ADDENDUM NO. 1

Skagit County Public Works

October 11, 2021

OVENELL SLOUGH (CEDAR GROVE CULVERT) REPLACEMENT PROJECT #WA402229 SRFB Project No. 18-1490R

1 INCH SCALE BAR
ADJUST SCALE ACCORDINGLY
SHEET
5 OF 23

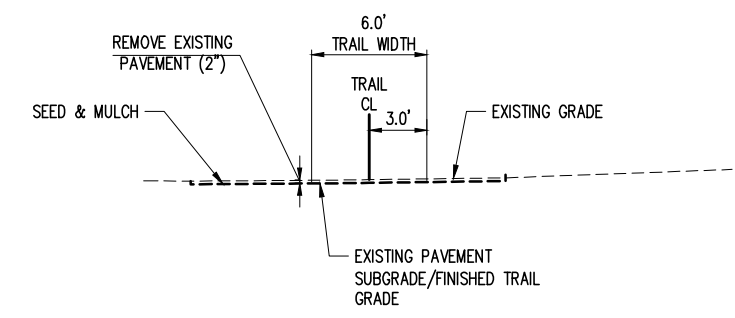
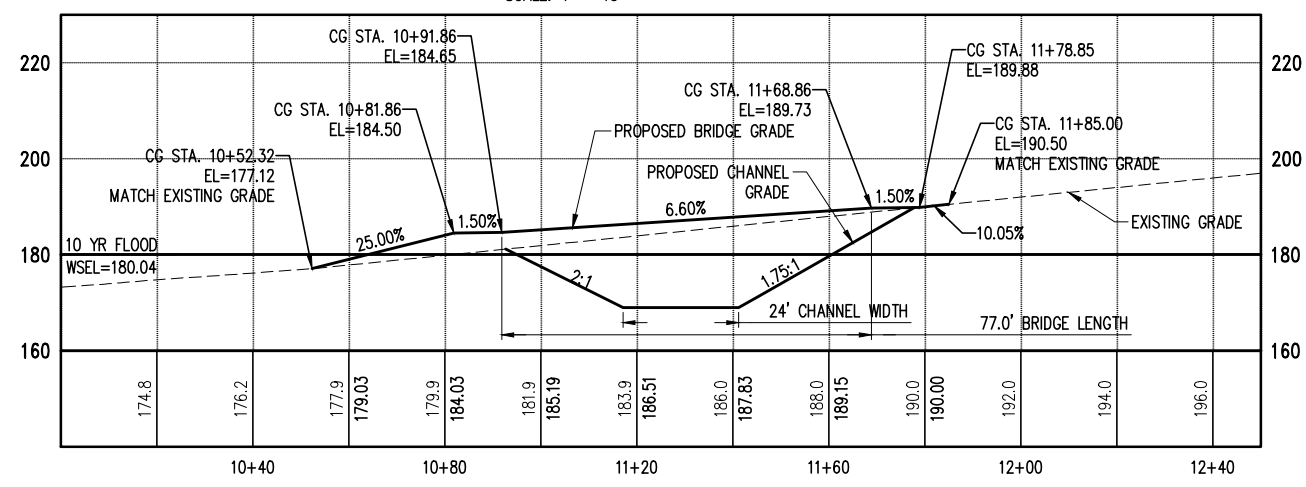
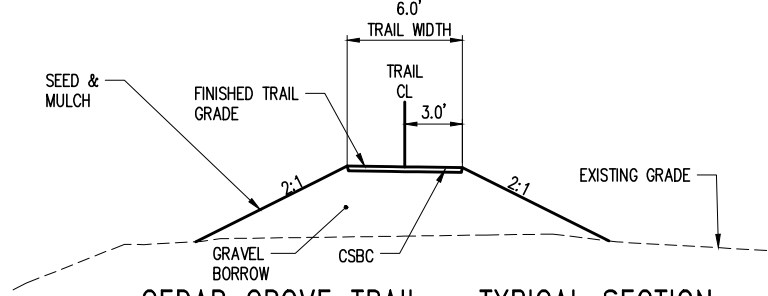
- Sheet 5 of 23: Added reference to the applicable WSDOT Std Plan in legend; Added stationing for beginning of Cement Conc. Sidewalk at Pier 2 in Plan view.
- Sheet 7 of 23: Revised note at bottom of channel in the Typical Section.
- Sheet 13 of 23: Changed reference from "Concrete Slab" and "Concrete Pad" to "Cement Conc. Sidewalk" in Plan.
- Sheet 20 of 23: Deleted "Weld Tie Section"; Revised rebar dimension in "Typical Girder Section".
- Sheet 22 of 23: Changed reference from "Top of Concrete Girder" and "Top of Concrete Pad" to "Top of Cement Conc. Sidewalk" in Elevation.
- Sheet 23 of 23: Changed reference from "Concrete Pad" to "Cement Conc. Sidewalk" in Detail 2; Added curb section at sidewalk.

5. Sheet 5 details the bridge landings as sidewalk but Sheet 13 details concrete pad / slab (Plans, Sht 5, 13). Please clarify the depth of the bridge landings or provide detail.
A: The landings shall be Cement Conc. Sidewalk per Section 8-14 of the project specifications. Labels will be changed on the structural plans as part of an addendum for consistency.

OVENELL SLOUGH CHANNEL IMPROVEMENTS - TYPICAL SECTION
SCALE: 1" = 5'

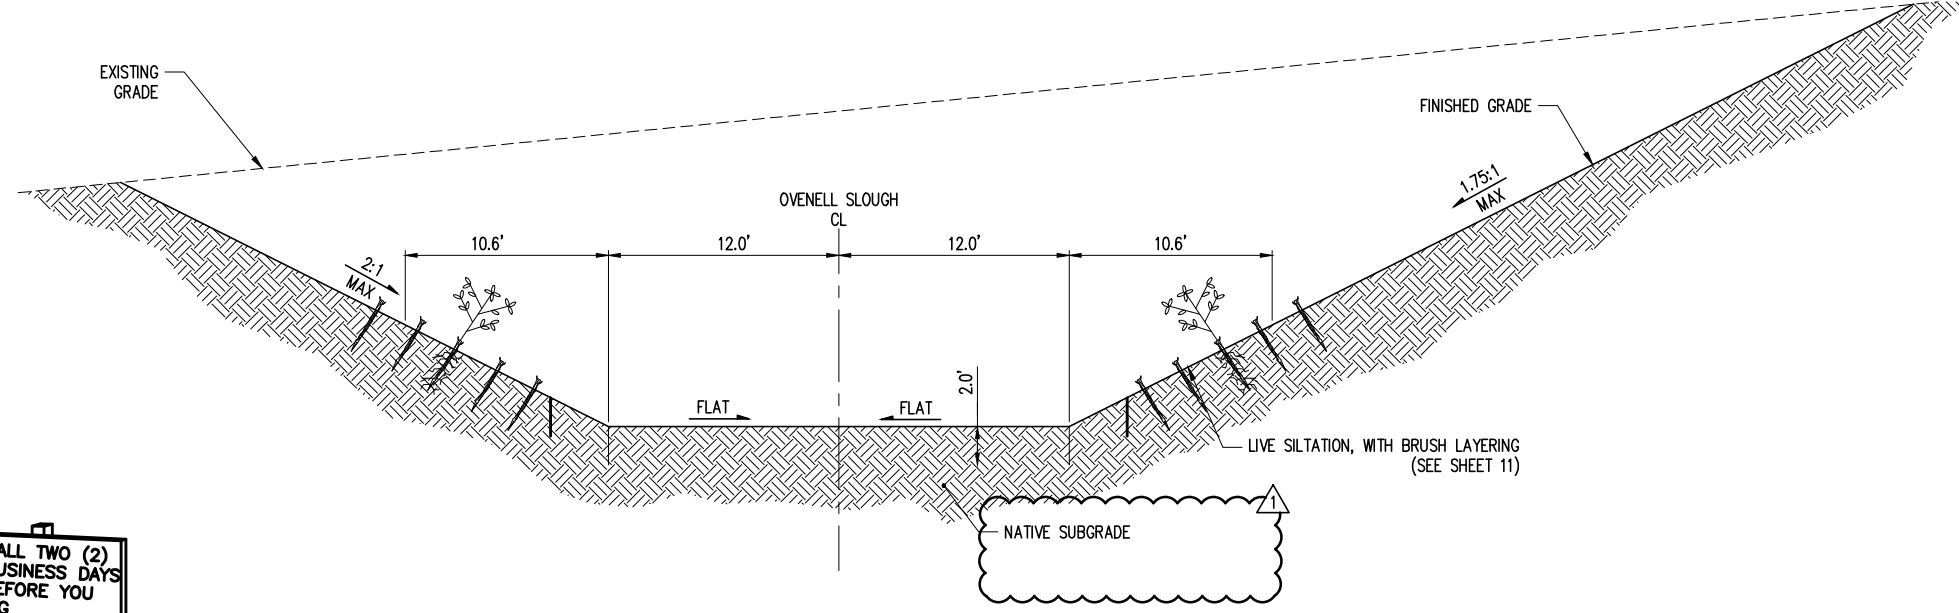
9. Sheet 7 of 23 has a note on the Typical Section that says - Replace Road Fill Materials with Streambed Sediment if found during Construction. Will additional Channel Exc Quantity be paid to dig out for the stream bed sediment? How do we get paid to stockpile and store streambed sediment if we find it?
A: No additional excavation is expected beyond the neat lines of the channel excavation limits. This note will be removed as part of an addendum.
